# Renaissance Apparels (new building)

C-S Plot # 659 & 660, Mouza 93, Gazipur, Bangladesh  
(23.985252, 90.353014)  
30<sup>th</sup> November, 2016

# Observations

Column size discrepancy

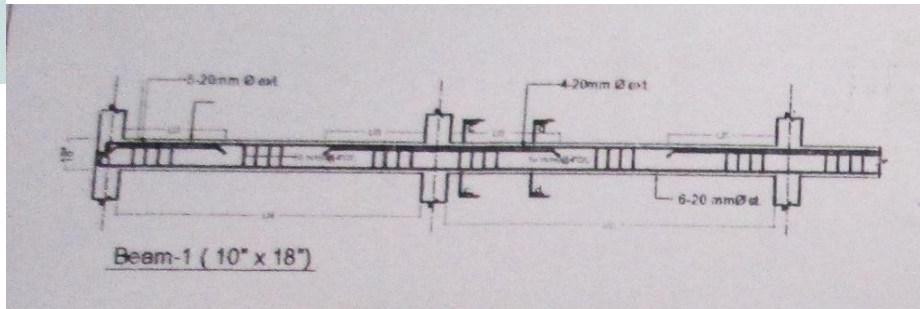
Dimensions of Column C-1 is mentioned 10"X15" in drawings, but we found it to be "12X15" in Part-A and 12"X12" in Part-B

Item No.	Observation	Recommended Action Plan	Recommended Timeline
1	Discrepancies on the as-built drawings	Building Engineer to produce a set of As Built Structural drawings as per As-built condition.	6-weeks
2	Exposed Rebar on roof	Remove the corroded portion and provide proper rust proof material	Immediate - Now
3	Exposed Rebar on roof	If further construction is intended, factory engineer to verify if the rebar's are in good condition and replace them if necessary.	6-weeks
4	Provision for future vertical Extension	If future vertical extension is intended, conduct DEA for the factory building following BNBC.	6-weeks
5	Provision for future vertical Extension	Implement any necessary remedial measures which will be the outcome of DEA.	6-months

Beam size discrepancy

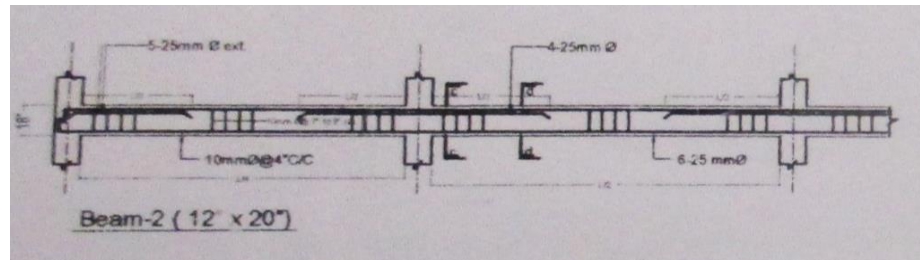
Dimensions of Beam-1 is mentioned 10"X18" in drawings, but we found it to be 12"X"20

Dimensions of Beam-2 is mentioned 12"X20" in drawings, but we found it to be 10"X15"

## Exposed Rebar on roof

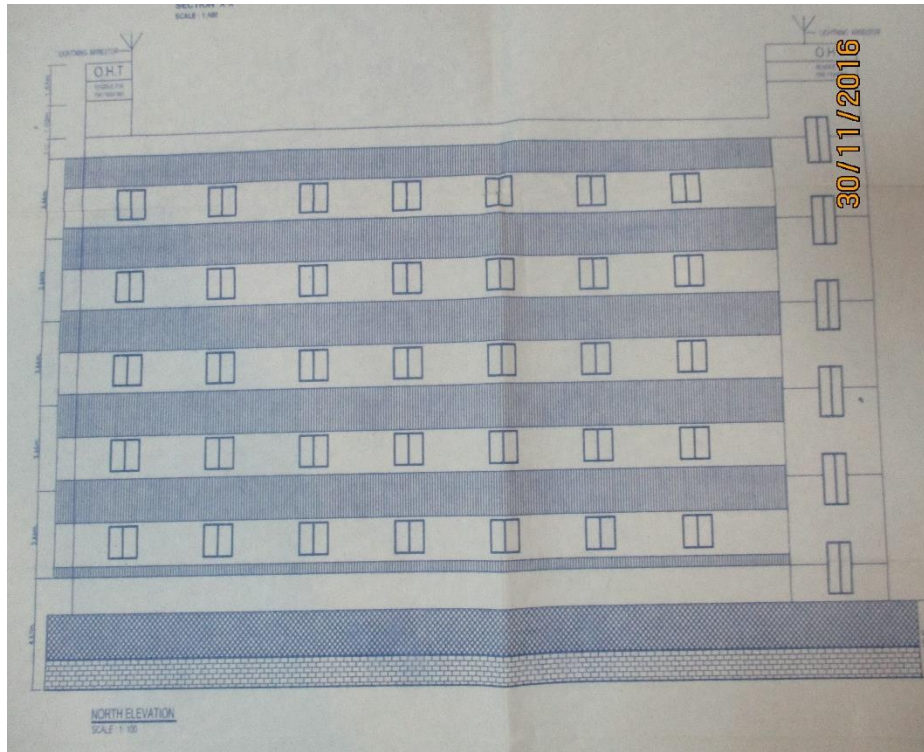
Exposed rebar's were observed at roof. Factory management informed us they will extend vertically in future, that's why they were kept in this condition. Rebar's were found in corroded condition.
